Revised Exhibit IV-15

SECTION
1
Independence
to
Odessa

EXHIBIT
IV - 15

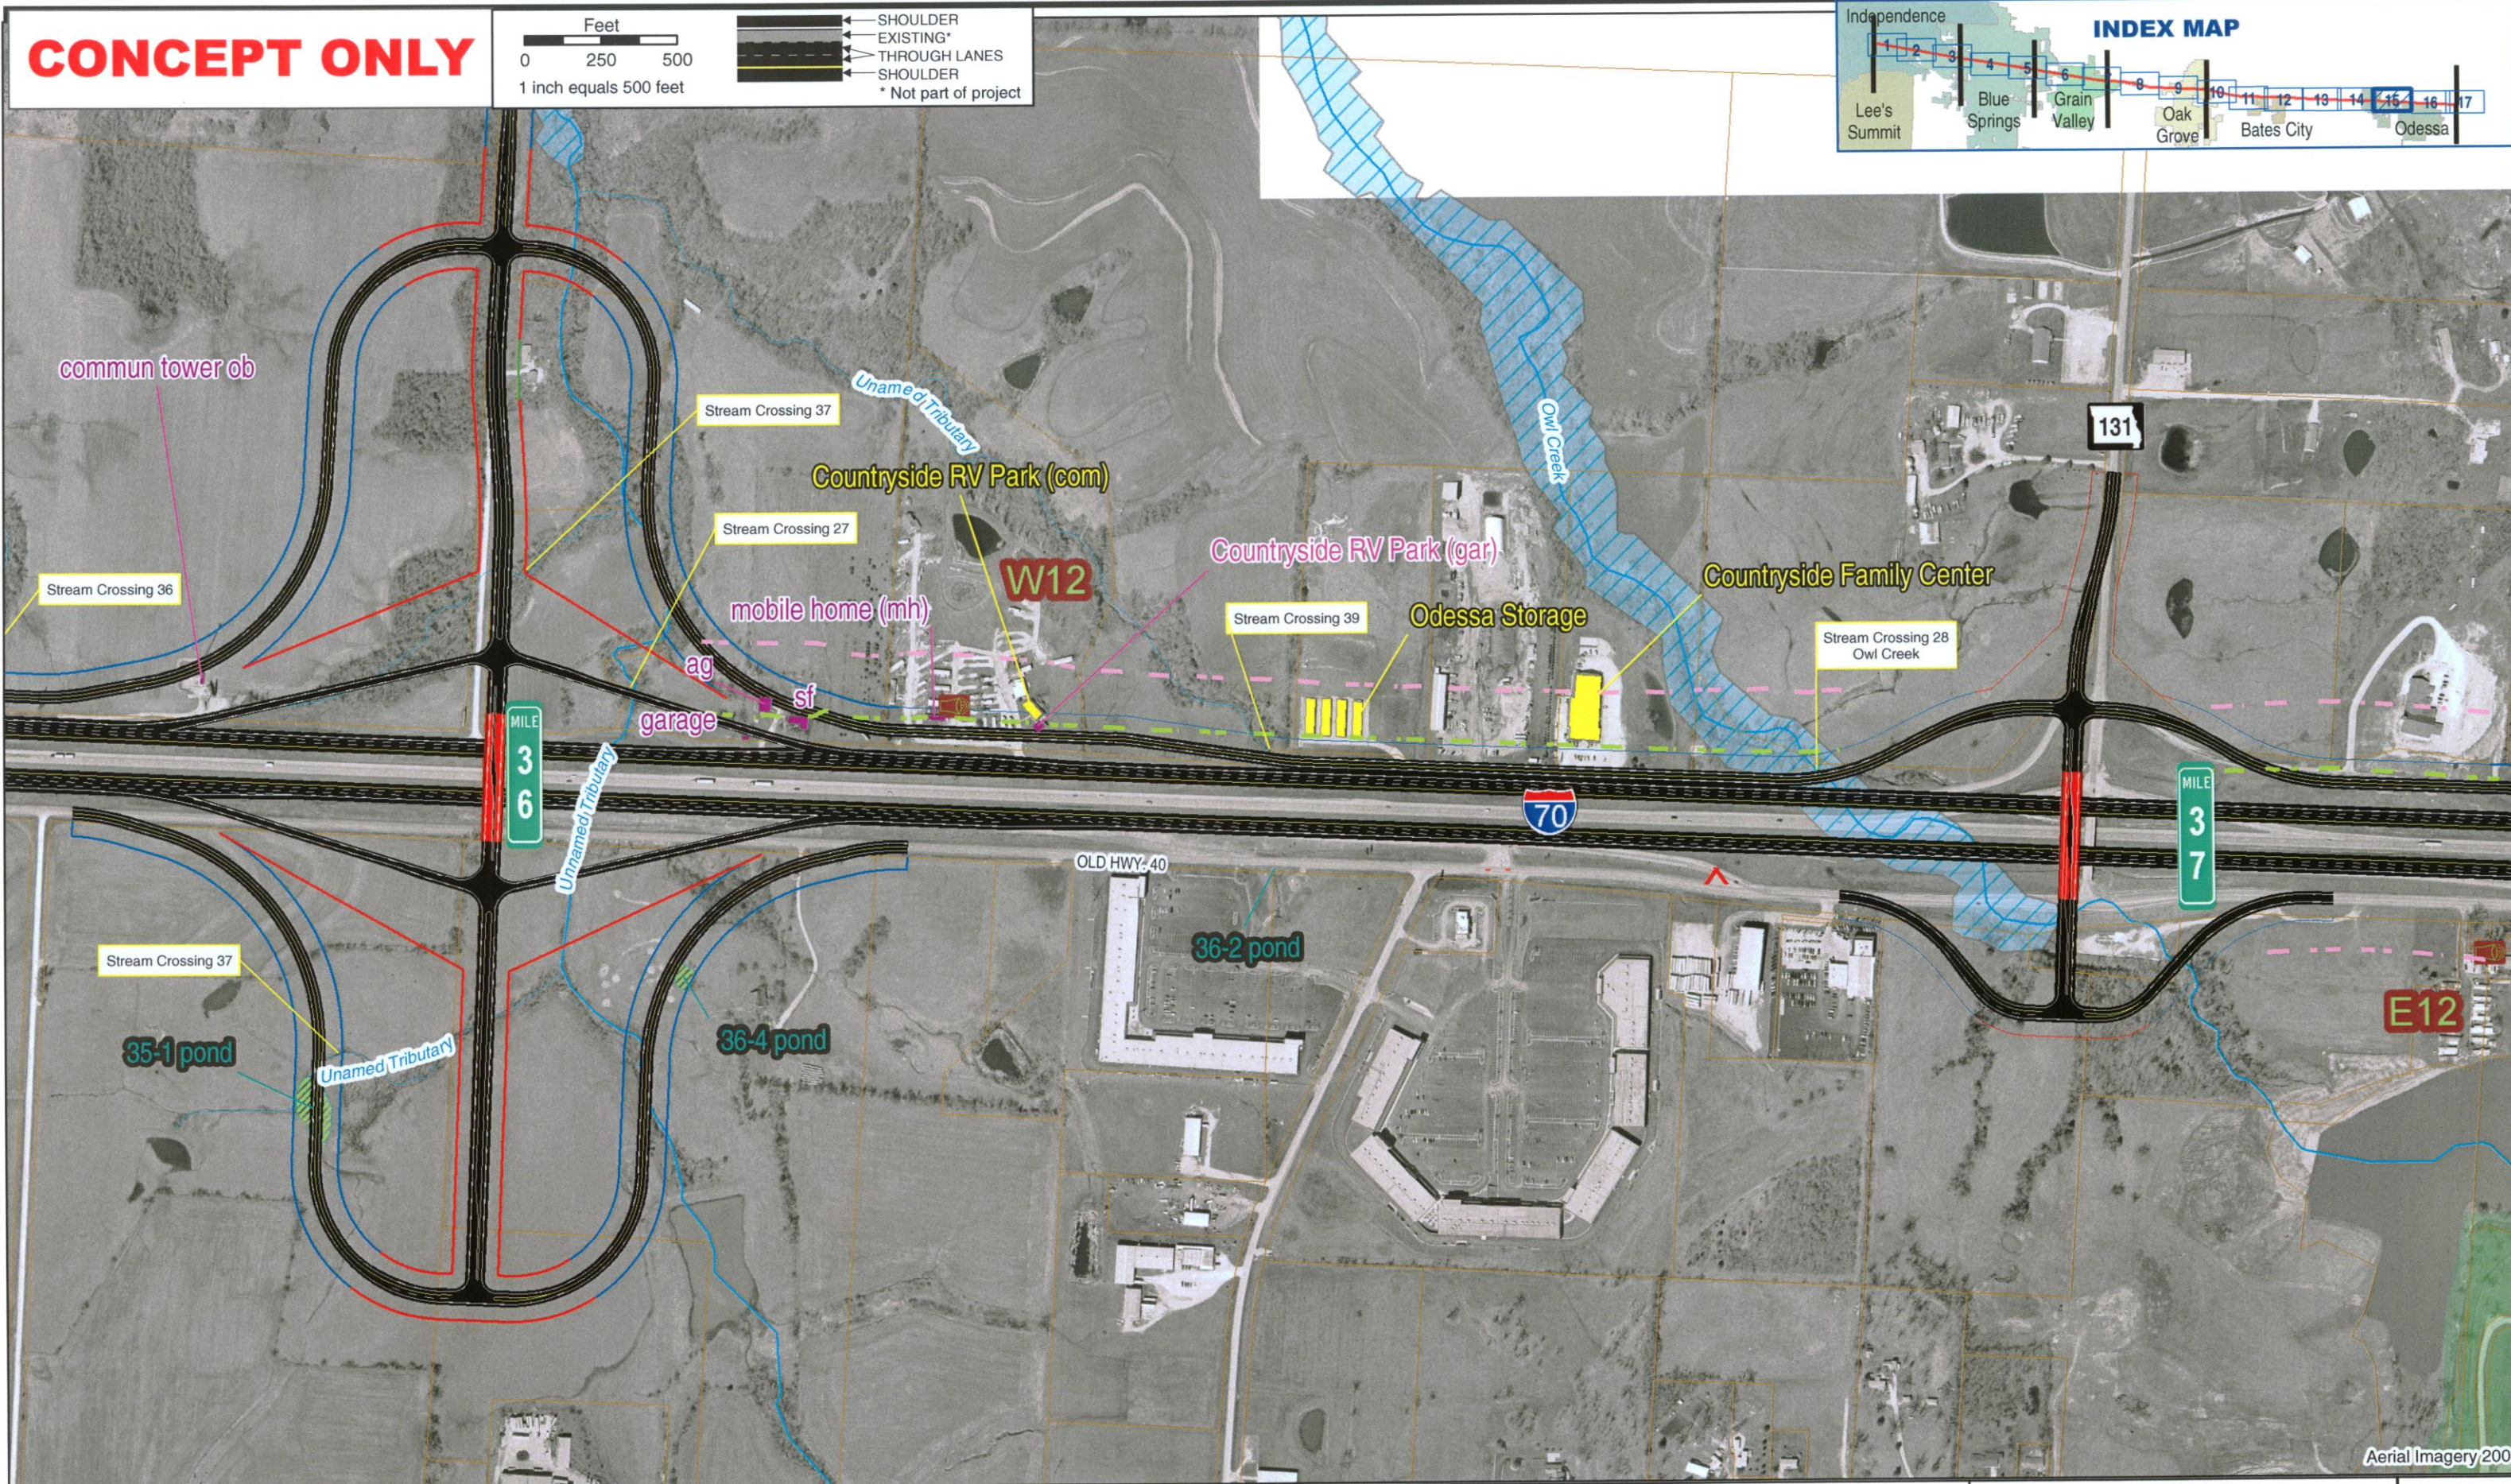
Exhibit IV-15 only depicts the area in western Odessa and the addition of a grade separation at Route 131. Exhibits of the entire SIU 1 corridor are contained in the Draft EA.
